### ADDENDUM No. 5

| REQUEST FOR QUOTATIONS No.: | 1220-040-2024-087   |
| TITLE:                      | City of Surrey - Operations Building Tenant Improvement     |

FLEX / BASKET CABLE TRAY

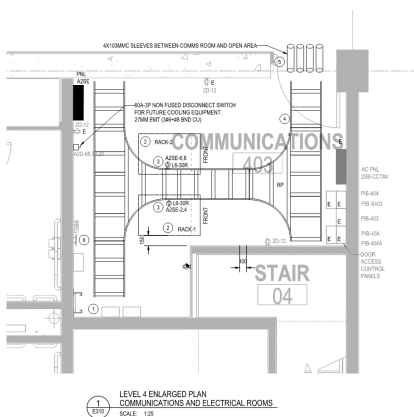
**Q3.** Please confirm basket tray is acceptable.

**A3. Refer to Electrical Addendum No. 3 issued November 21, 2024.**

**Q6.** Drawing General Note B on E103 states:

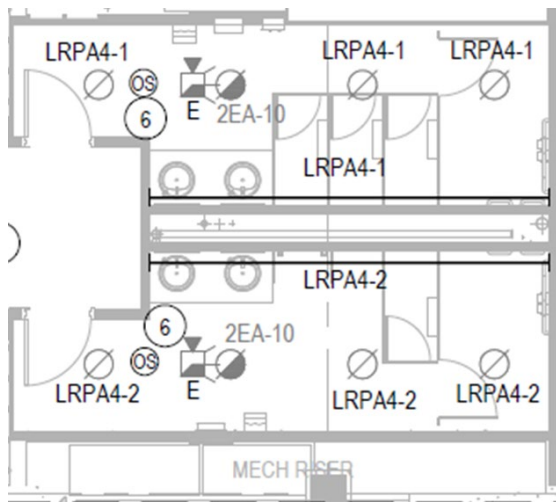
- B. ALL EXISTING FIRE ALARM SYSTEMS ON LEVEL 2 SHALL BE PROTECTED DURING AND AFTER CONSTRUCTION AND REMAIN AS IS. CONTRACTOR SHALL ALLOW TO REMOVE AND REINSTALL EXISTING FIRE ALARM DEVICES AFFECTED DURING CONSTRUCTION.

This contradicts itself, are we to allow to remove and re-install all fire alarm devices shown on the Level 2 drawings (which would require re-verification)?

Or are there specific areas we will need to re-install the fire alarm devices? Please clarify how many devices and where.

**A6. Refer to Electrical Addendum No. 3 issued November 21, 2024.**
